U.S. Patent Application No. 10/648,387 Docket No.: 20300/60302

Amendment in response to Office Action of 7/07/06

Appl. No. 10/648,387 Reply to Office action of July 7, 2006 Annotated Sheet Showing Changes

Fig. 3

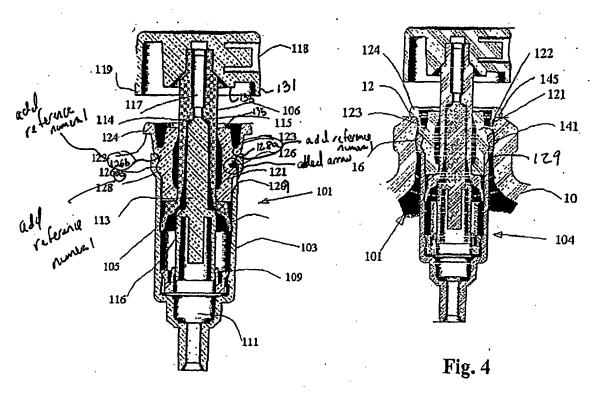
In the Office action dated July 7, 2006, the Examiner allowed claims 15-19 and objected to claims 1 and 6 for claiming subject matter not shown in the drawings. In addition, claims 1-13 stand rejected under 35 U.S.C. § 102(e) as allegedly being anticipated by U.S. Pat. No. 3,724,726 to Susuki et al.

Applicant amended paragraph [0027] of the specification to reflect the addition of reference numerals 126a, 126b, and 128a to Fig. 3. Applicant submits that no new matter is added.

As noted above, in FIG. 3, reference numerals 126a, 126b, and 128a are added to identify claimed subject matter.

The attached drawing sheets include changes to FIG. 3. This sheet, which includes FIGS. 2-4, respectively, replaces the original sheet. In FIG. 3, reference numerals 126a, 126b, and 128a are added.
